# Access Compliance Report Public Rights-of-Way (RR Crossings)

Intersection ID: 10025543	Main Street: E_TRADE_ST	Location: N/A
ADA ID: 541A1CB50D28	Overall Compliance: No	Severity Score: 0.0
Codes/Mitigation Info/Possible Solution		Field Measurements/Component Compliance

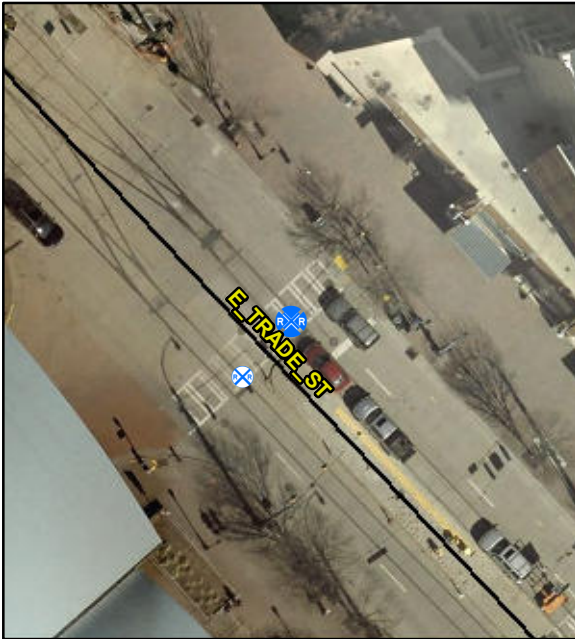
**RR IN MIDDLE OF STREET**

Compliance	Description	Data
No	DWS Provided?	No
N/A	DWS Contrast?	N/A
N/A	DWS Width (in)	N/A
N/A	DWS Length (in)	N/A
N/A	DWS Offset (in)	N/A
No	Pedestrian Gate?	No
N/A	DWS Outside Gate?	N/A
N/A	Rail Type?	LightRail
No	Flangeway Gap (in)	2.5
Yes	Sidewalk Width (in)	114.0

**Install Detectable Warning System.  
Provide Pedestrian Gate. Remove &  
Replace Walking Surface Adjacent  
to Rail.**
